Work Order ID 79884

Item Name: Crosstube Assembly, Mid Fwd

DART AEROSPACE LTD HAWKESBURY, ONTARIO, CANADA	
DRAWING NO. D206-667-147	REV. A SHEET 1 OF 4
TITLE CROSSTUBE ASS'Y (206L MID FWD)	SCALE NTS

DRAWING NO. D206-667-147	TITLE CROSSTUBE ASS'Y (206L MID FWD)	REV. A	DART AEROSPACE LTD ENGINEERING ORDER		D.E.O. NO. D206-667-147-A-1	SHEET NO. SHEET 1 OF 1	SCALE NTS
DRAWN 92	CHECKED ASS	MFG. APPR. [Signature]	APPROVED [Signature]		DE APPR. [Signature]		
DATE 11.07.15	DATE 11.07.20	DATE 11.07.21	DATE 11/07/21		DATE 11.07.21

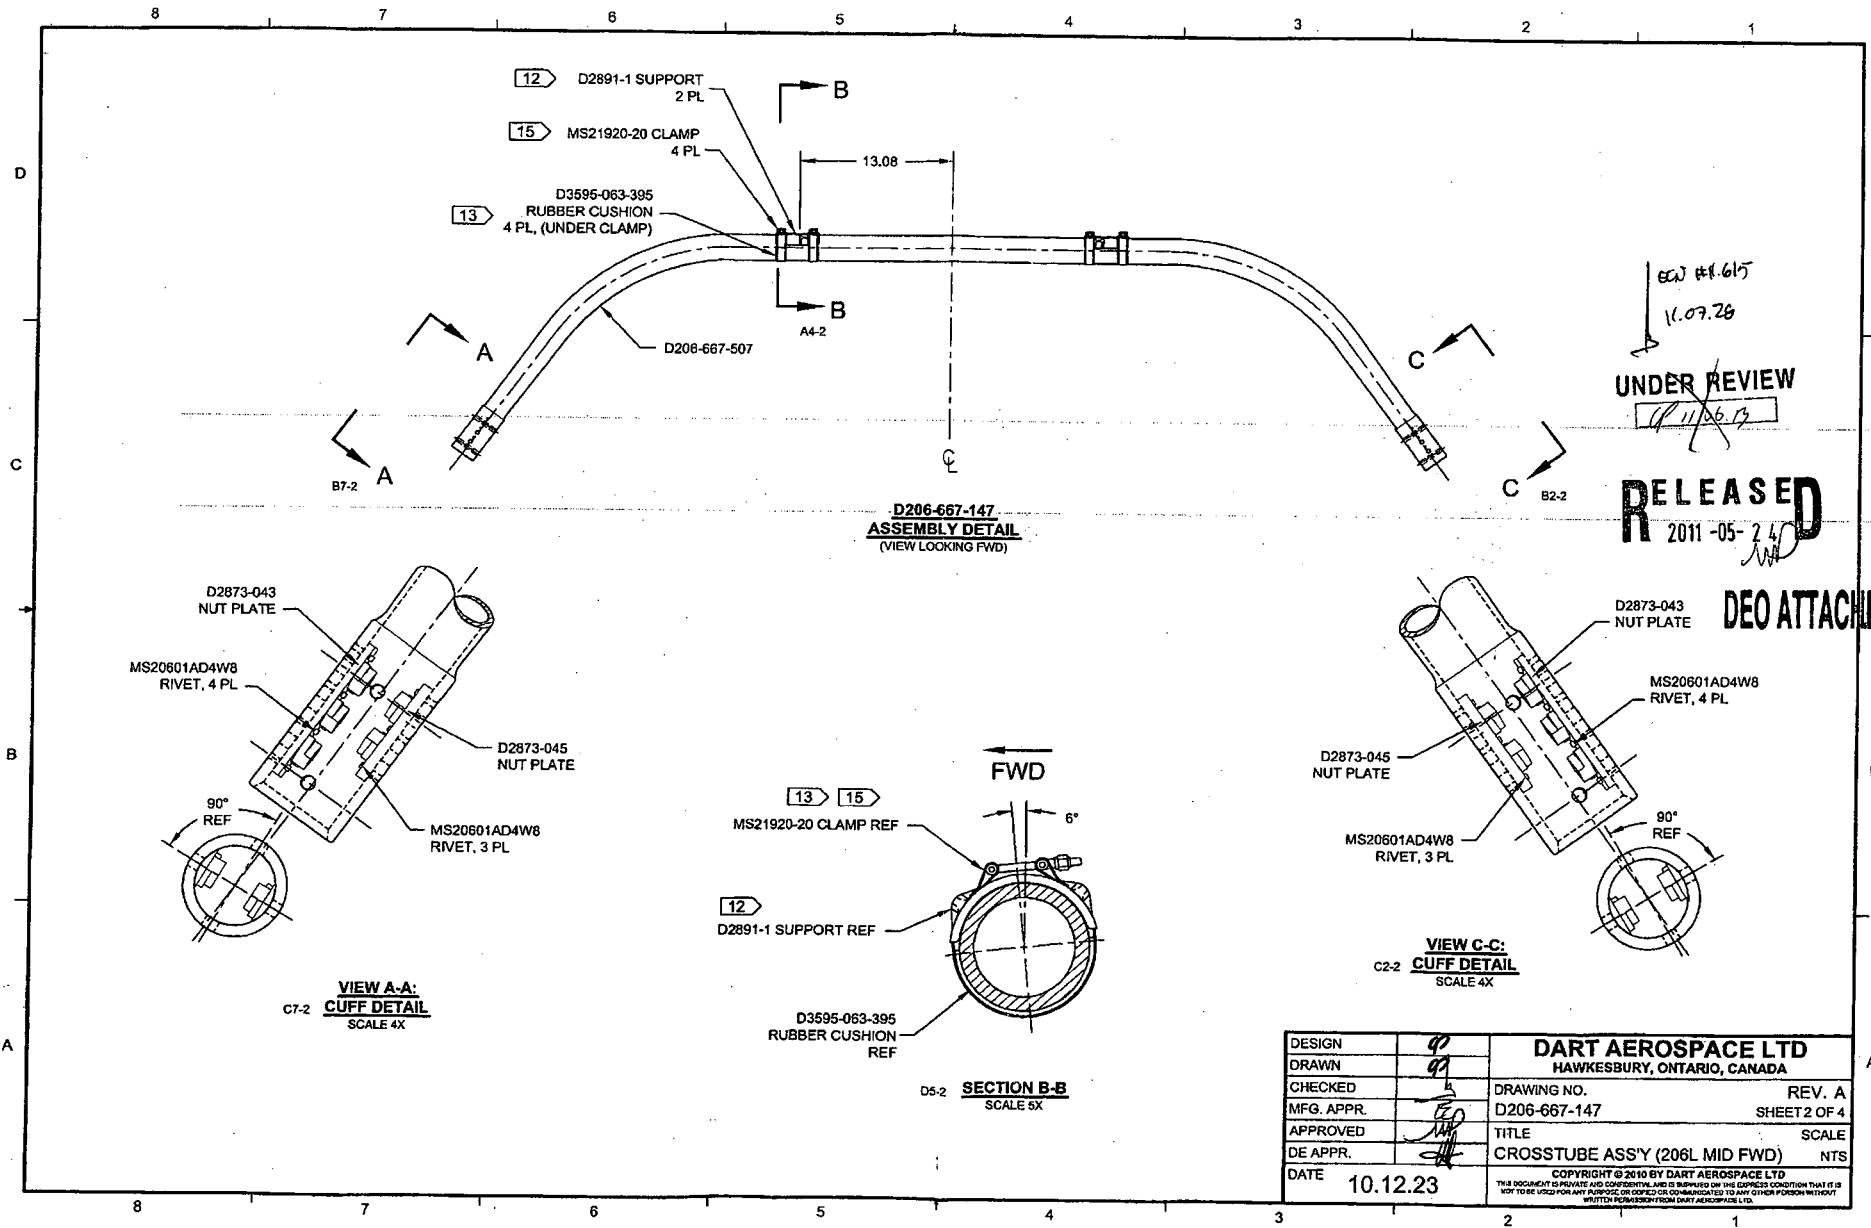
PURPOSE:

REPLACE MAGNOBOND WITH PROSEAL.

NOTE 12 & 15, SHEET 1 IS AMENDED AS FOLLOWS:

- 12) INSTALL D2891-1 SUPPORT USING 0.03" TO 0.06" THICK LAYER OF MAGNOBOND 6398 PER QSI 015. LET CURE FOR 12 HOURS AFTER INSTALLATION AND PRIOR TO PACKAGING.
- 15) TORQUE CLAMPS 80 TO 100 IN-LB. ENSURE AT LEAST 1.5 THREADS SHOWING IN SAFETY AND THAT NUT HAS NOT BOTTOMED-OUT AFTER TORQUING.

- 12) TO INSTALL D2891-1 SUPPORT: ABRASE MATING SURFACE OF SUPPORT AND CROSSTUBE WITH 180-GRIT SANDPAPER AND REMOVE RESIDUE WITH MEK (OR EQUIVALENT). APPLY A 0.04" TO 0.07" THICK LAYER OF PROSEAL 890 CLASS B-2 (OR AMS-S-8802 CLASS B-2) SEALANT TO MATING SURFACE OF SUPPORT.
- 15) TORQUE CLAMPS 80 TO 100 IN-LB. ENSURE AT LEAST 1.5 THREADS SHOWING IN SAFETY AND THAT NUT HAS NOT BOTTOMED-OUT AFTER TORQUING. **PRIOR TO PACKAGING, RE-CHECK TORQUE ON CLAMPS AFTER PROSEAL 890 SEALANT HAS CURED FOR 72 HOURS.**
